MIL-M-28787/436
AMENDMENT 1
25 May 1994

MODULES, STANDARD ELECTRONIC

MEMORY CONTROL MODULE, KEY CODE JMN

FIGURE 11b. Dynamic waveforms for table XVII - Continued.

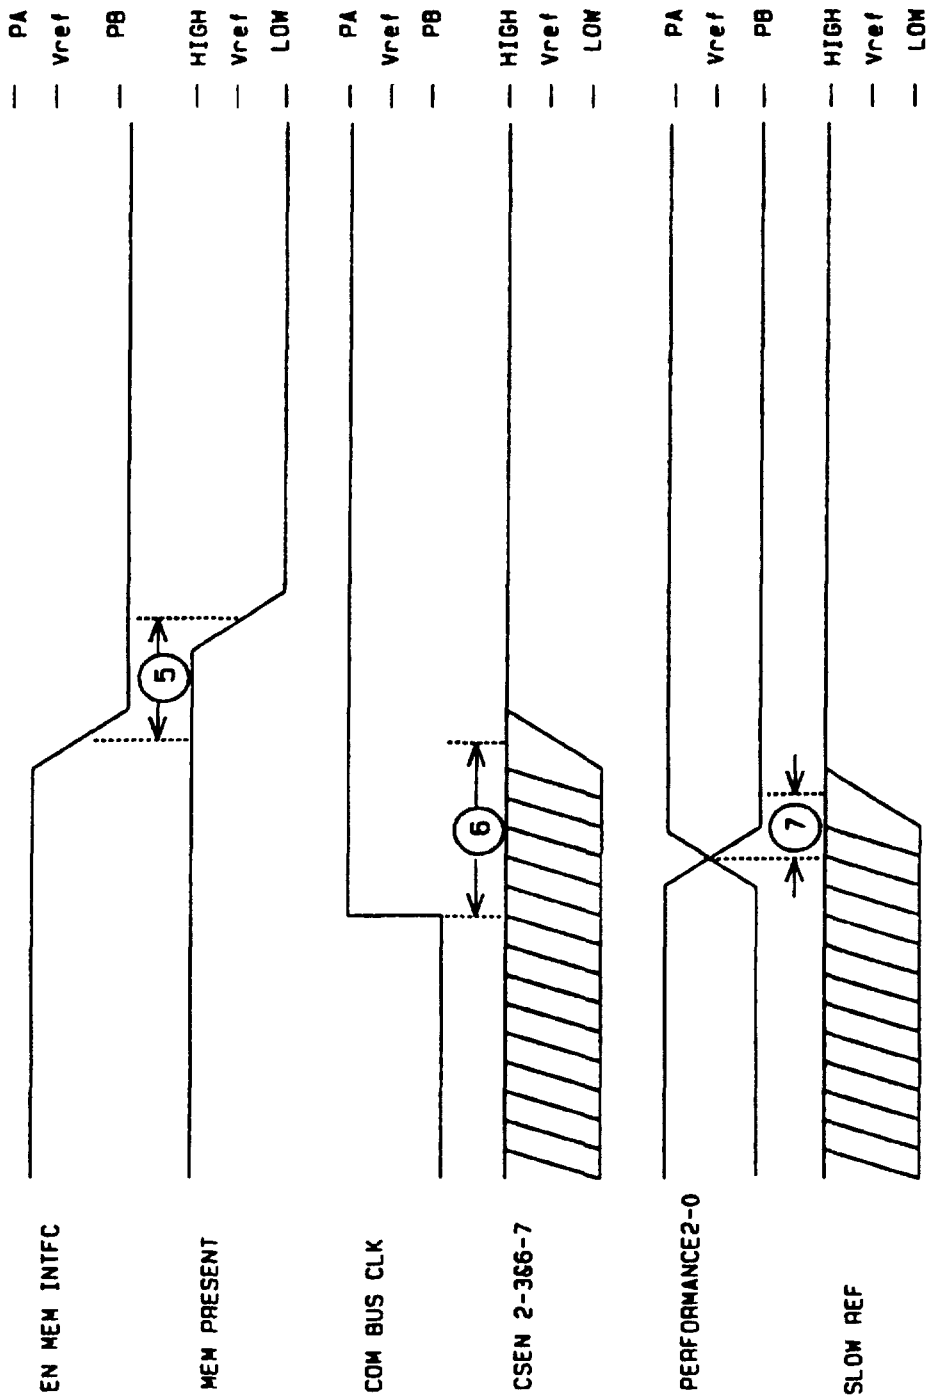
FIGURE 11b: Delete and substitute new figure 11b as printed on page 4 of this amendment.
